RE: Application PZ23-000004 (DEV)
Oak Creek Heritage Lodge, Comprehensive Review,
Planning, Engineering, and Sustainability Comments

Response to Planning Comments dated October 27, 2023:

See sheet A2-07 Restaurant roof plan. Screened HVAC equipment are identified as shown.

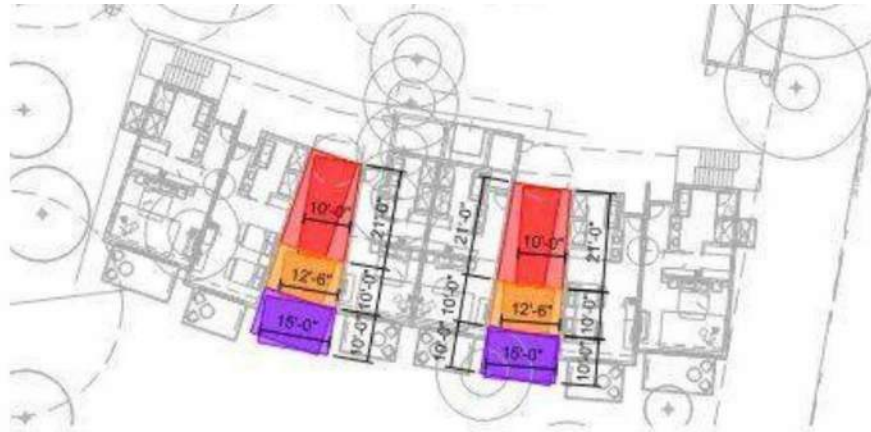
c) *LDC Section 5.6.D (Screening): Show location and screening method for all roof-mounted mechanical equipment, ground mounted mechanical equipment, and loading, service, and refuse areas.*

The LOI indicates that rooftop equipment will be used and refers to roof plans. The roof plans do not include rooftop equipment other than solar panels. Clarify.

See sheet A3-01 Meeting Room roof plan. Screened HVAC equipment are identified as shown.

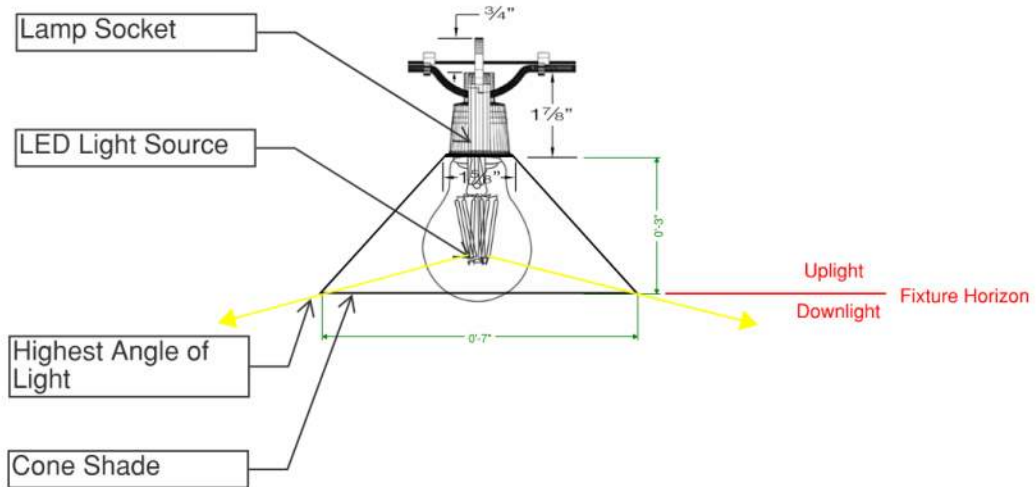
i) The CFA Plan, along with the historic surveys submitted with the application, indicate that the Farley/Steele Ditch may be eligible for landmark status. Indicate location on the plans. As stated in this code section, this ditch must be integrated into the development. Sheet T0-06

The response to comments states both sections of the irrigation channel will remain. Sheet T0-06 states one will be modified. Clarify.

WATG: Sheet T0-06 Has been corrected. The typo was corrected to match all other documents. “Existing irrigation channel to remain”. Additionally, see the added reference to the reuse of the façade materials of the original residence on the Pool Bar and Heritage Gallery Building.

See sheet A2-13 for revised Pool Bar & Pool Pump/Restroom design. The design team is utilizing and repurposing the materials and design of the existing 1950’s original residence to hold the Pool Bar and Heritage Education Gallery functions. The building is placed at the entry of the site and pays homage to the early heritage of the agricultural settlers through planted orchards. This is in response to the PNZ workshop discussion.
